TECHNICAL BULLETIN

Rough Idle/Engine Misfire – New Spark Plug Wires and Routing

18-43

MODEL XJS Range (V12) and XJ12 DATE 11/94

ILLUSTRATION 1

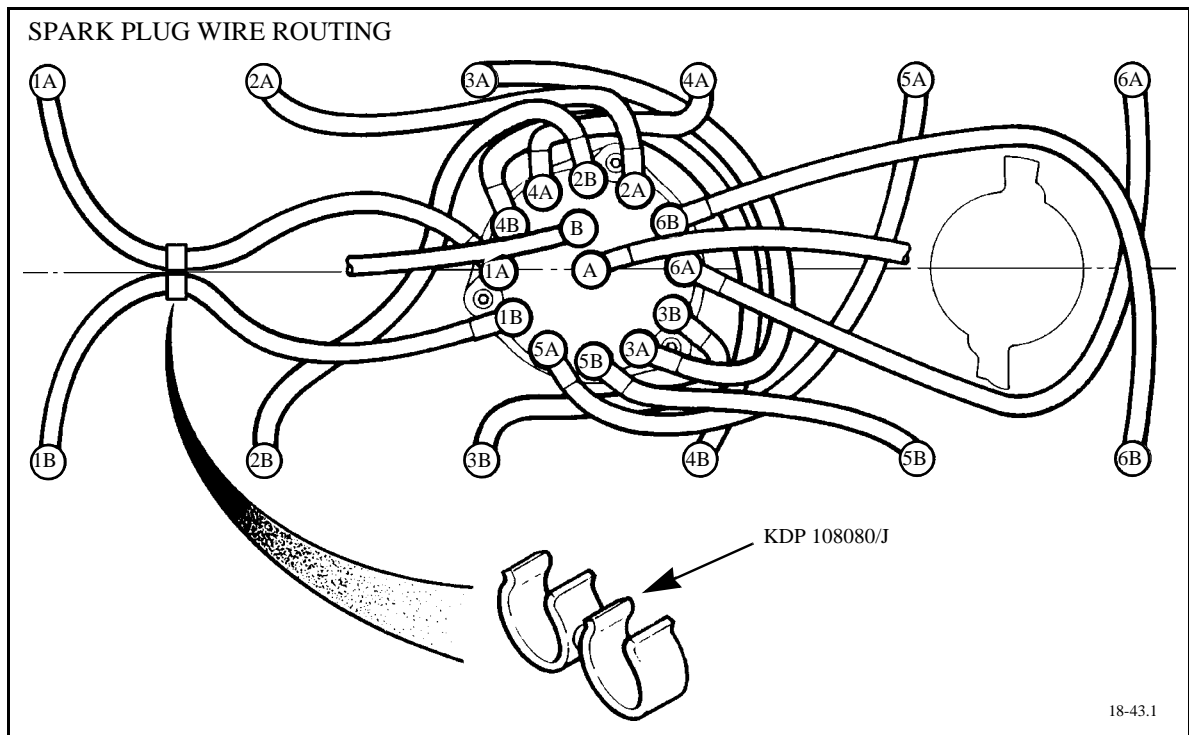
Rough idle and engine misfire conditions that develop after approximately 20,000 miles may be caused by high voltage leaks between the spark plug wires and cylinder head bolts.

New spark plug wire sets with revised routing were introduced in production from the following VIN numbers.

Route the new wires as shown in Illustration 1.

IMPORTANT: The clip (P/N KDP 108080/J) must be installed on the spark plug wires for cylinders 1A and 1 B as shown in the illustration.

If customers complain of engine misfire or rough idle after approximately 20,000 miles on V12 vehicles produced before the VIN numbers shown above, replace the spark plug wires with the latest version.
